#### FOI request to the Greater London Authority submitted on 17 August 2016

CONSIDERATION BY THE MAYOR OF LONDON OF CAMDEN COUNCIL'S PLANNING APPLICATION AT CENTRAL SOMERS TOWN COVERING LAND AT POLYGON ROAD OPEN SPACE, EDITH NEVILLE PRIMARY SCHOOL 174 OSSULSTON STREET AND PURCHESE STREET OPEN SPACE LONDON NW1 – REF: NO. 2015/2704/P AND 2015/7168/L – APPLICATION UNDER THE ENVIRONMENTAL INFORMATION REGULATIONS 2004

## CENTRAL SOMERS TOWN - APPLICATION REFERENCE 2015/2704/P APPLICATION BY THE LONDON BOROUGH OF CAMDEN

# CENTRAL SOMERS TOWN APPLICATION REFENCE – 2015/2740/P RESPONSE TO REPRESENTATIONS FROM THE FRANCIS CRICK INSTITUTE

#### **OVERLOOKING**

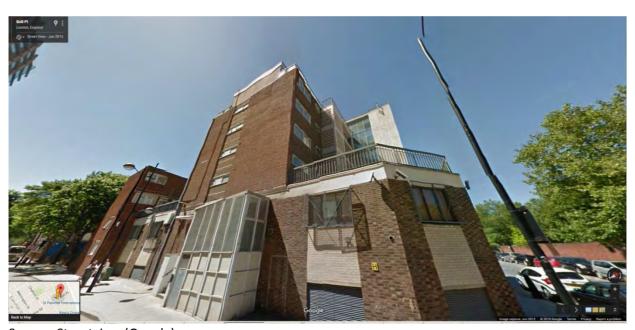
The analysis work undertaken by the applicants to assess the possible views into the research laboratories has only considered the horizontal plane and the potential impact at levels 1 - 4. It has not addressed the fact that views from floors in Brill Tower will look down, from height, into the Crick building.

In designing the laboratories the Crick was required to consider views looking upwards from the adjoining road network, public spaces and tangential views from Phoenix Court on Brill Place.

Contrary to the impression given in the analysis study that was undertaken by the Council, the windows within the southern elevation to Phoenix Court are high level and contain opaque glass, being related to the bathrooms of each of the three units. These are not windows that provide easy views and do not relate to habitable space (see Photos 1 & 2).

Further, with respect to the tangential views from the three windows on the south eastern corner of the Phoenix Court, there were concerns over whether these would have views into the sensitive parts of the Crick. Indeed the original case officer should recall visiting one of the units to assess actual sight lines and the conclusion reached was that there would only be, at worse, glimpses across Brill Place to the building. Notwithstanding that, the internal layout has been designed so as not to give sight lines to more sensitive areas. Indeed there are no laboratories in the visual plane from any existing building.

The analysis that has been carried out has also only considered views based on standard residential dimensions of habitable room to habitable room. Given the downward plane and the nature of activities that will take place within the internal areas of the Crick building this standard is inappropriate for this assessment. There is no scenario where direct views into those internal areas would be acceptable.

Accordingly, we do not consider that our concerns in this area have been adequately addressed for us to remove our objection. We continue to have considerable concern over the potential of views into the inner core of the building. This has a direct impact on the residential amenity of potential future occupants.

Plot 7 NW B17

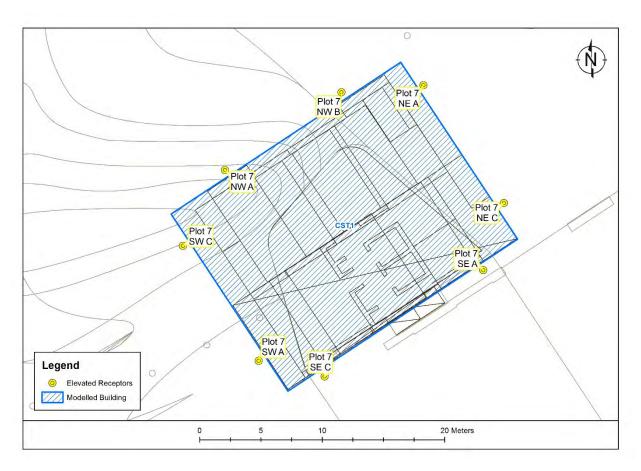
A summary of the results for floors 15 and above from these runs are presented in Table 1 below. The full results are presented in Appendix 1. The receptor locations are shown in Figure 1. No results have been presented for Plot 7 NW A and Plot 7 SW C as the building does not extend past floor 14 in this location.

remove pollution from the incoming air. This would allow the residents to use these spaces during periods of high air pollution with the windows sealed. A similar solution should be provided on floor 15, for the winter garden in the eastern corner of the building. Given the short term, infrequent nature of the high pollution events it is not proposed to seal the winter gardens shut.
